Subject: RE: Hairball Project

See comments in attached PDF from operations review as well as additional comments from Carla/Peter below:

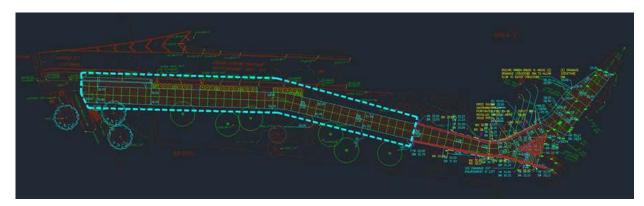
- -l agree with removing planting in the sloped triangular area near the ramp. I'd suggest we replace this with riprap considering the slope. Would you also like us to remove the planting at the 3' buffer and replace with boulders?
- -I've added six buckeyes south of the path
- -I'll add skatestops to handrails, and a "notched" skatestop detail for the walls (John, we can coordinate).
- -We'd like to clarify the vehicular access-- we recommend only accommodating vehicles on the western side of the project, and not anything within the retaining walls or beyond in the area under the on ramp. This seems to be in line with the current loop that vehicles make in this area. If you agree we can show a 6" concrete path in the part of the path outlined with a dash below, and 4" everywhere else:
